R E M A R K S

Preliminary Amendment
H. UMEDA et al

Amendments to the Drawings:

FIG. 11

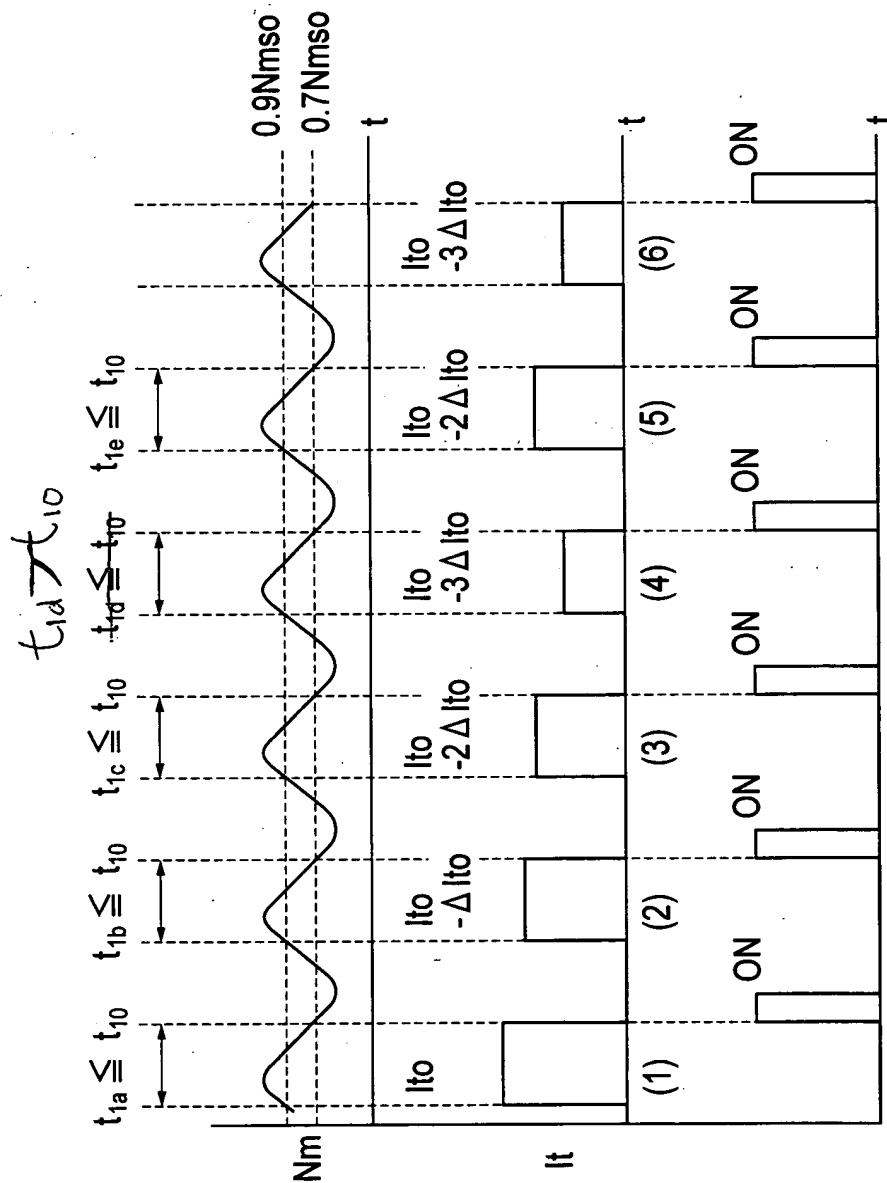
Fig. 11 of the drawings has been amended to change " $t_{1d} \leq t_{10}$ " to " $t_{1d} > t_{10}$ ". No new matter has been added.

Fig. 11 has been amended as indicated on the attached annotated sheet to change " $t_{1d} \leq t_{10}$ " to $--t_{1d} > t_{10}--$.
